**SAN ANTONIO WATER SYSTEM
NACO PUMP STATION IMPROVEMENTS PROJECT
SAWS PROJECT NO. 12-6003
SOLICITATION NO. B-14-005-DD
ADDENDUM NO. 3**

February 20, 2014

The purpose of this addendum is to issue a revision to the Contract Documents, plans and specifications for the Naco Pump Station Improvements Project (SAWS Job No. 12-6003).

PROPOSED ONE-LINE DIAGRAM - PART 1

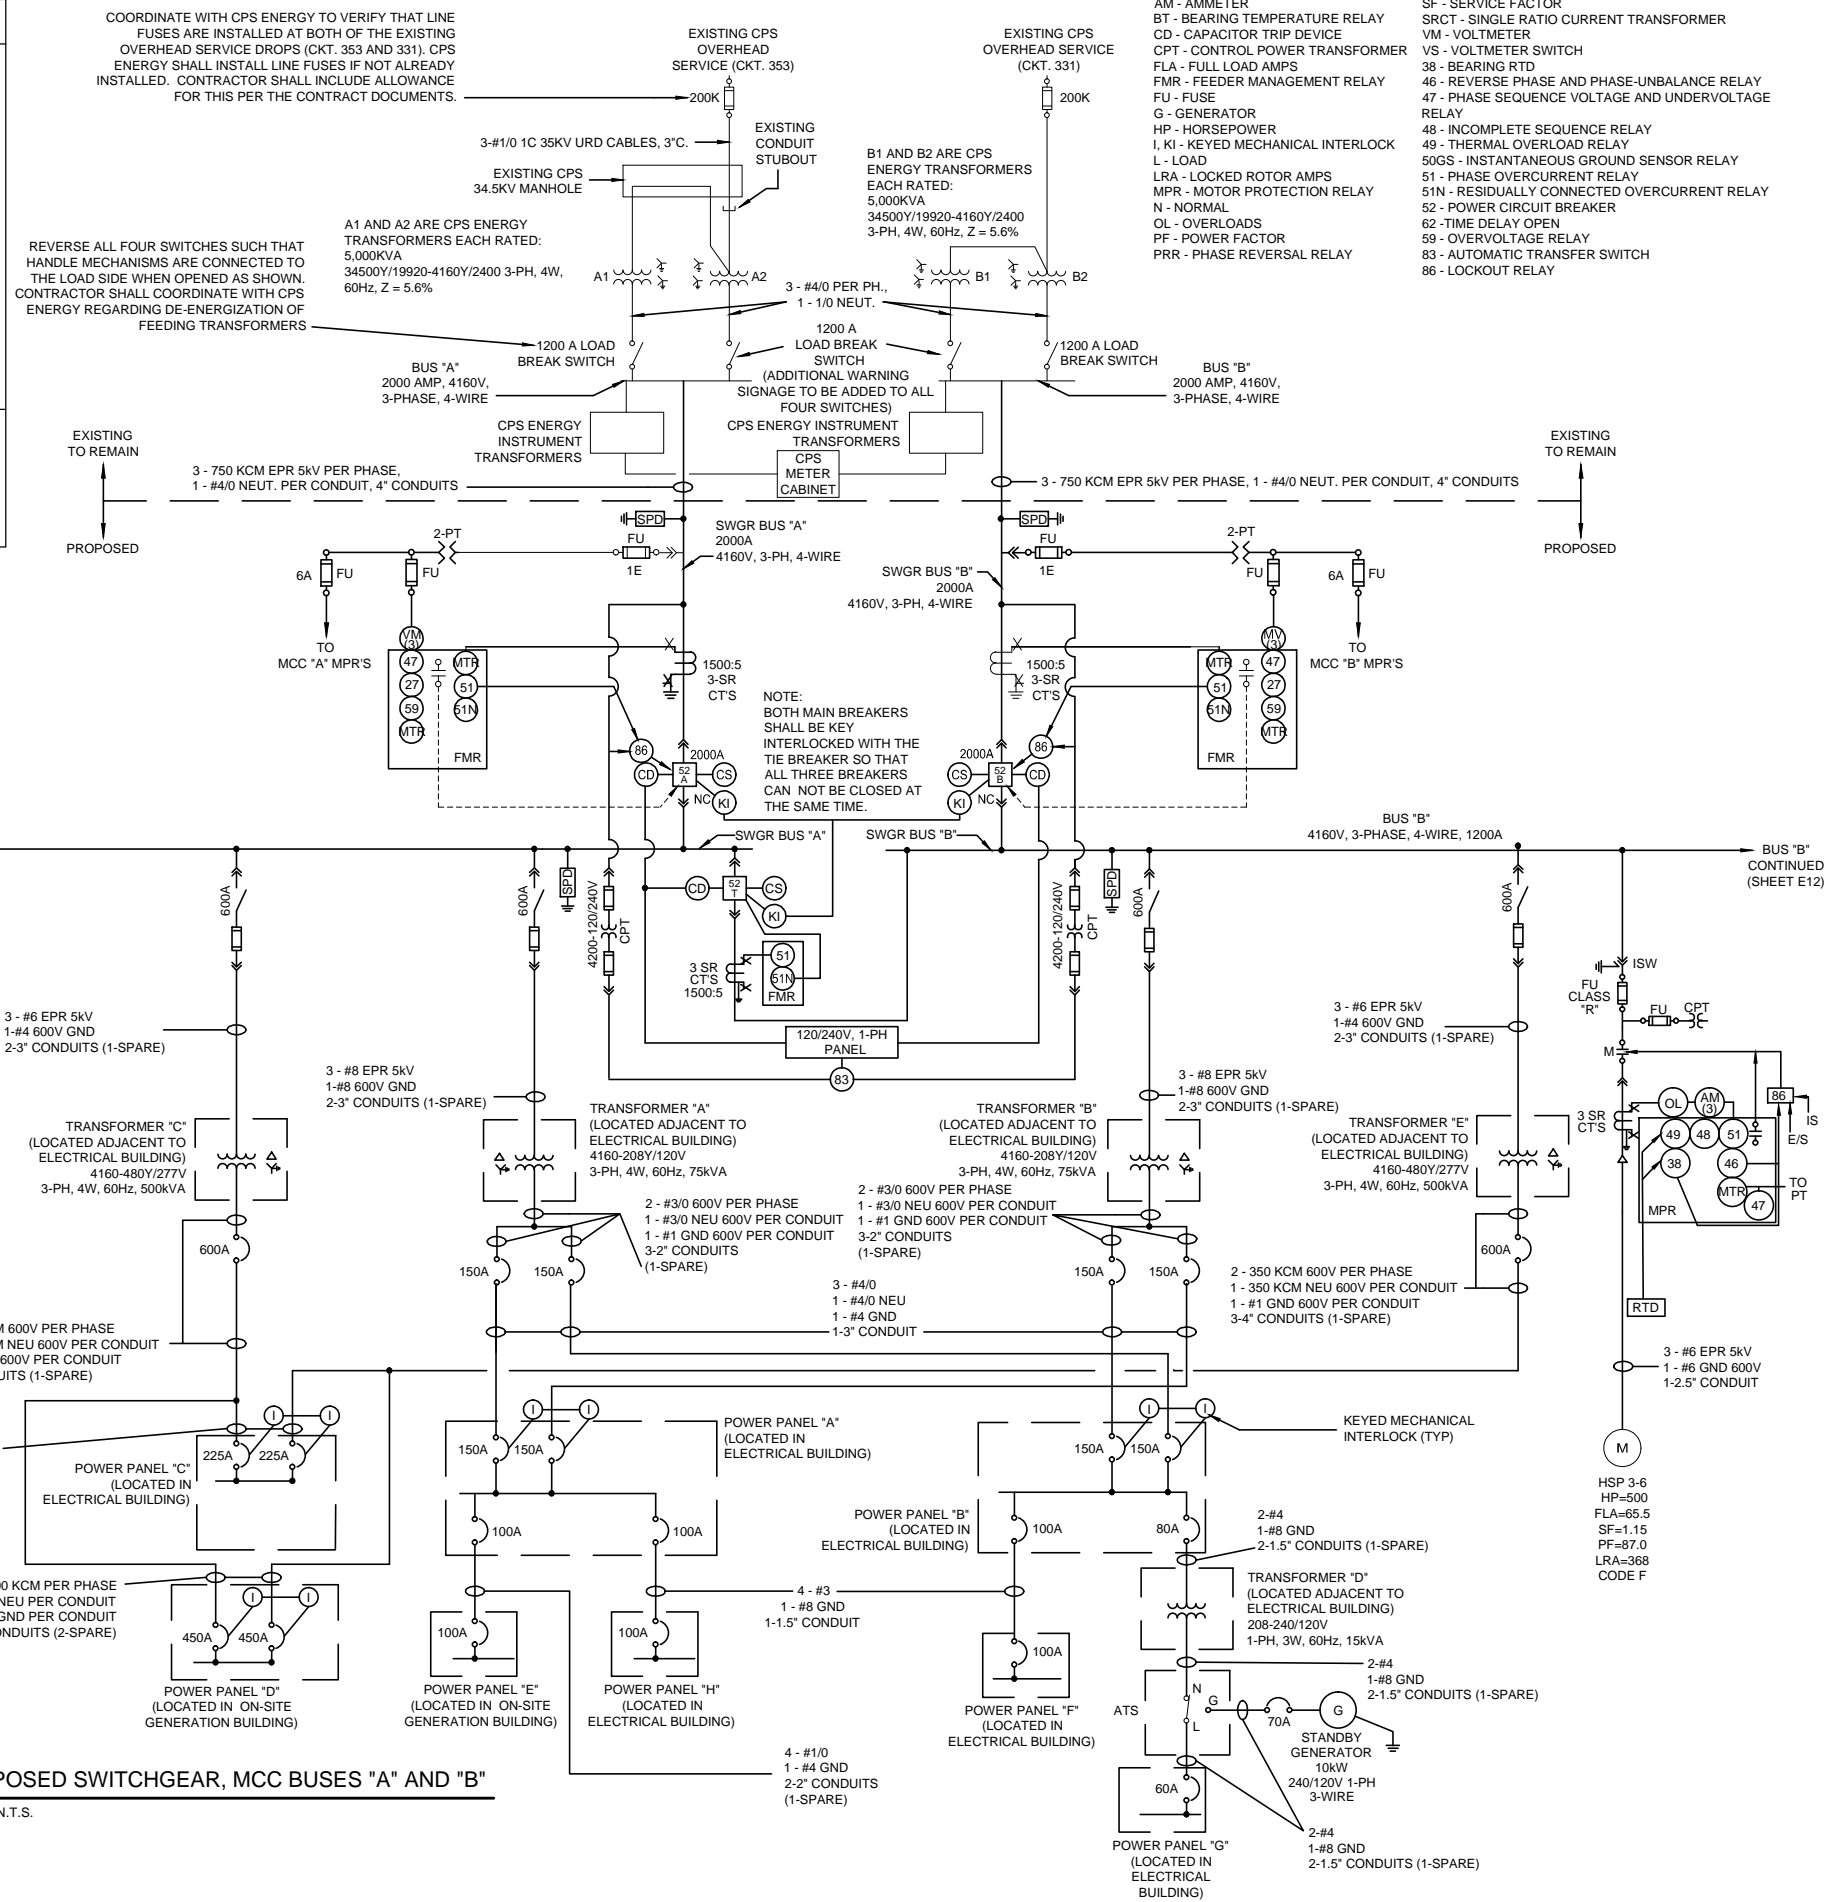
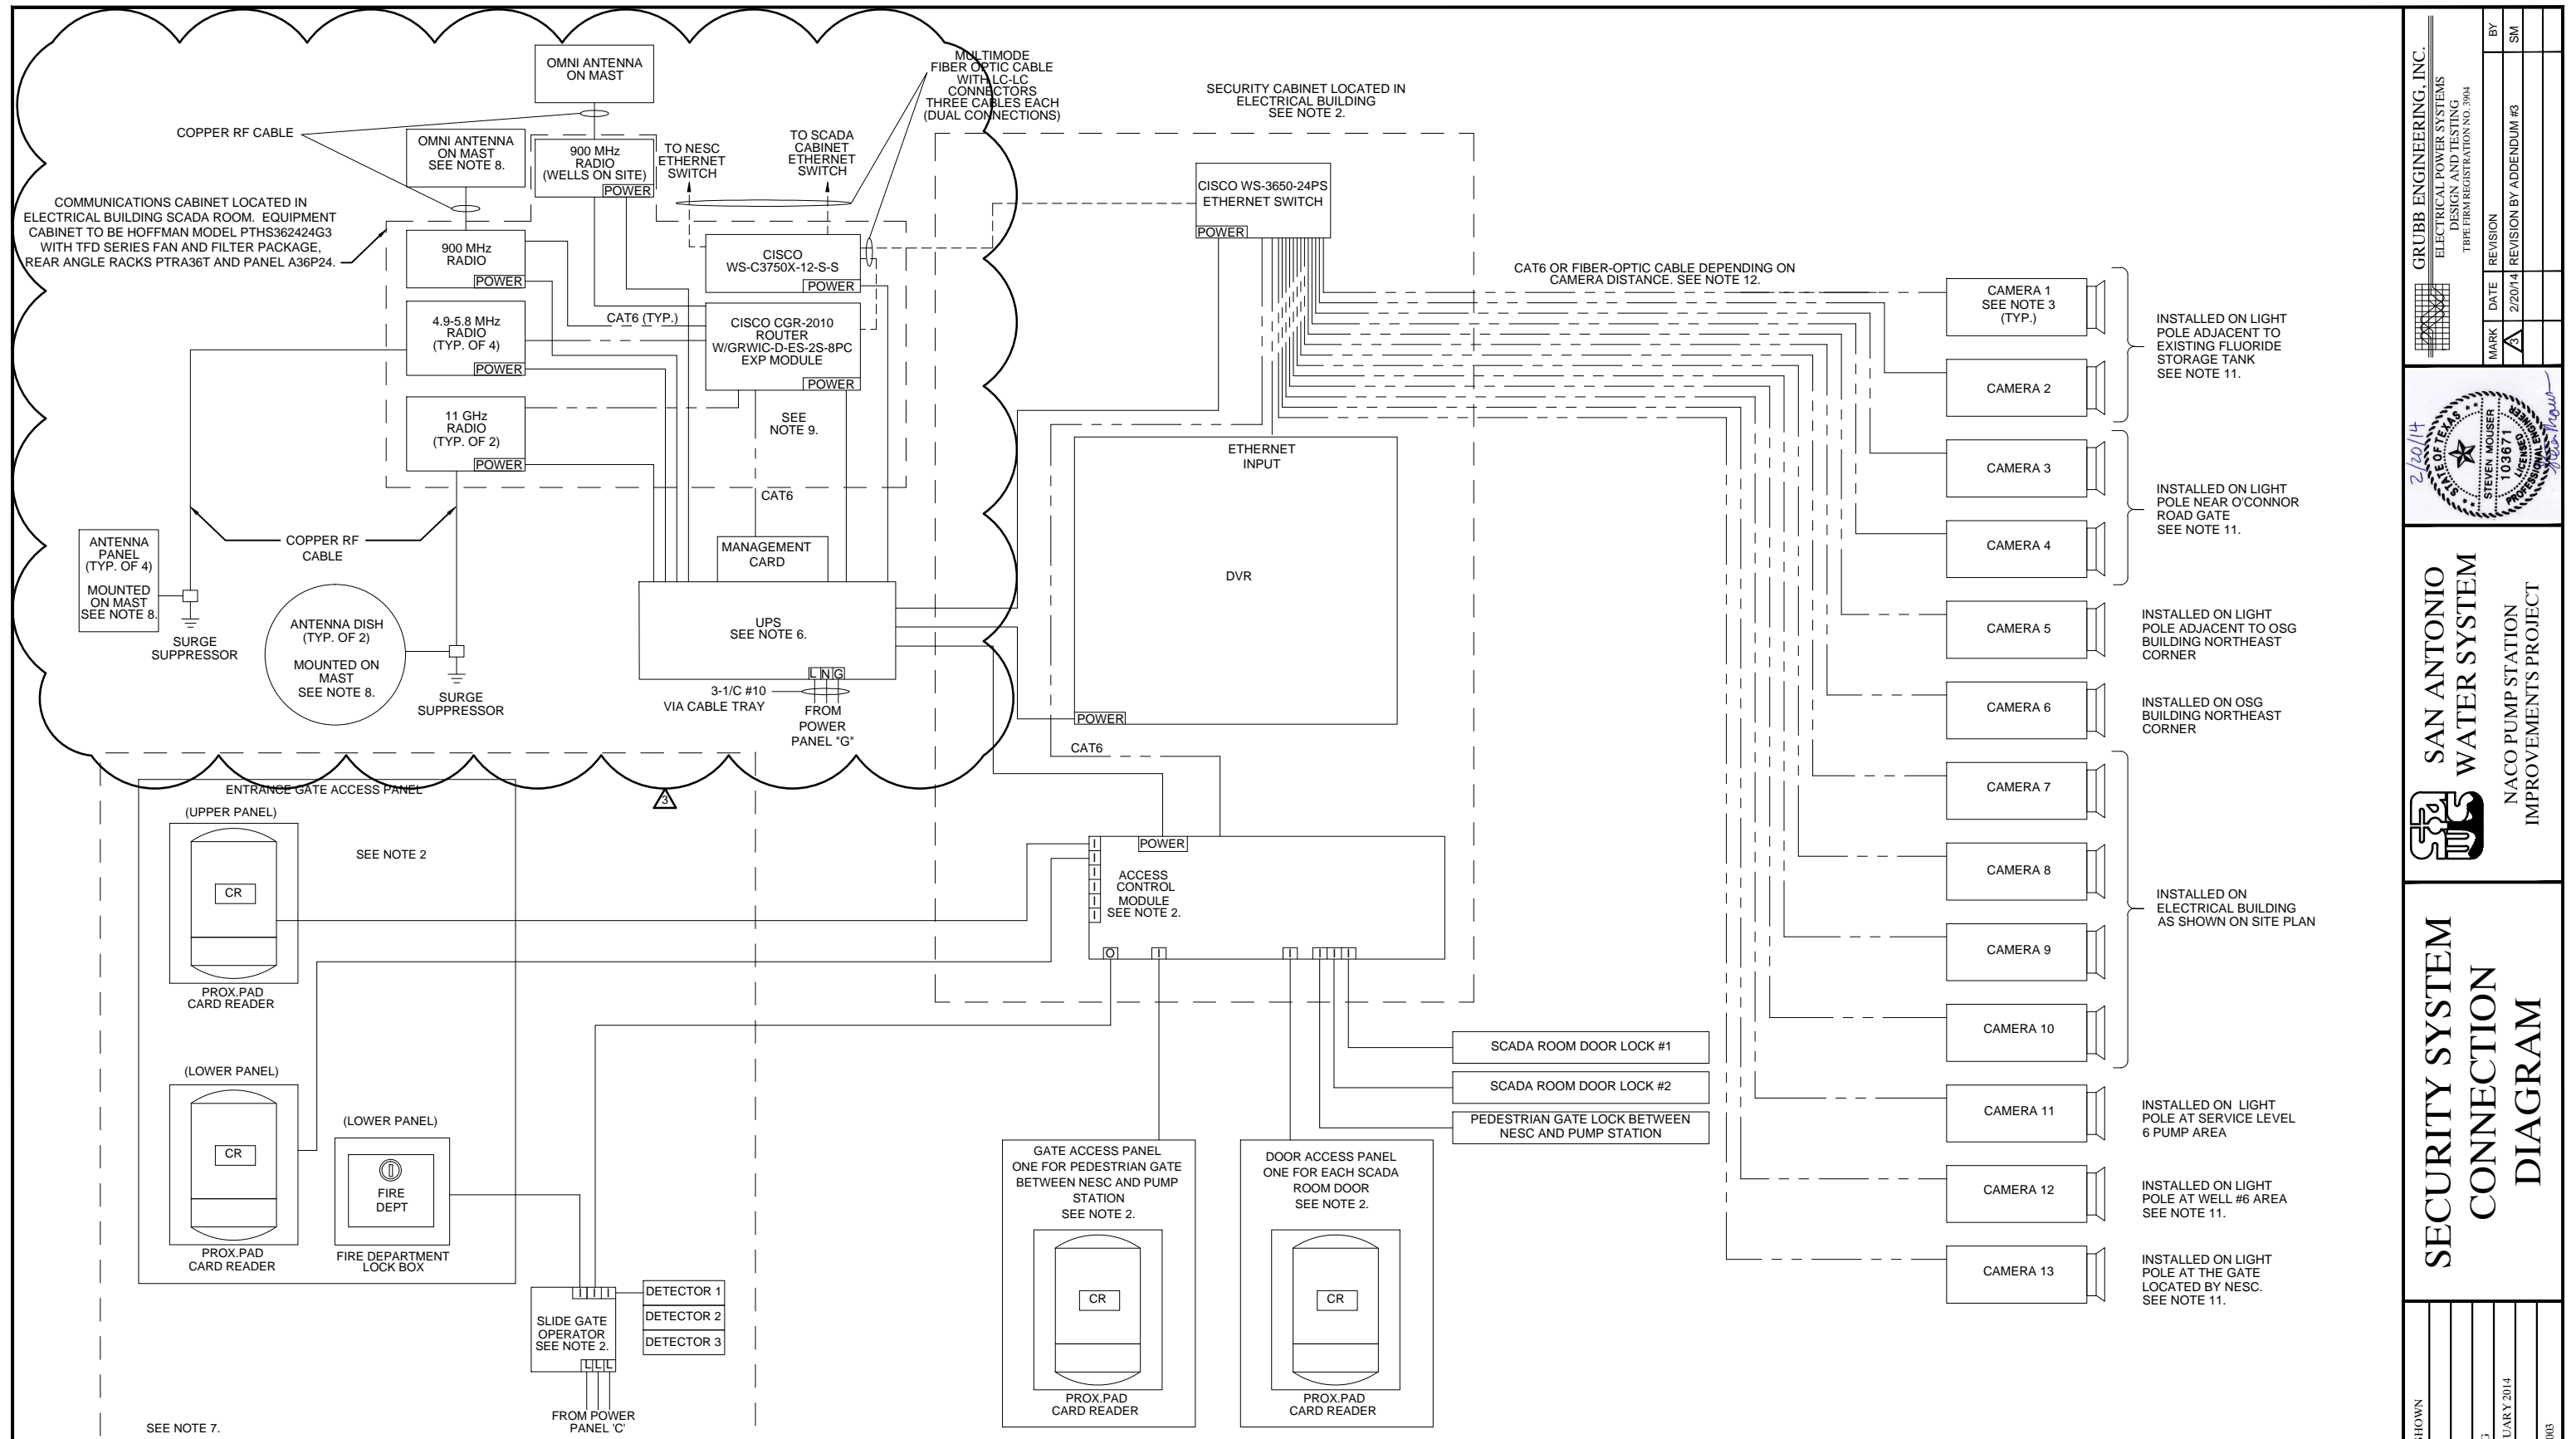
4. On sheet E11, WP 7 indicates there is 3 – 4/0 5 KV cable to a 900 HP motor with FLA of 119 and on sheet E12, WP 6 indicates there is 3 - #1 5 KV cable to a 900 HP motor with FLA of 119. Please advised.

4. Sheet E11 has been revised. Reference Part 4.0 of this Addendum.
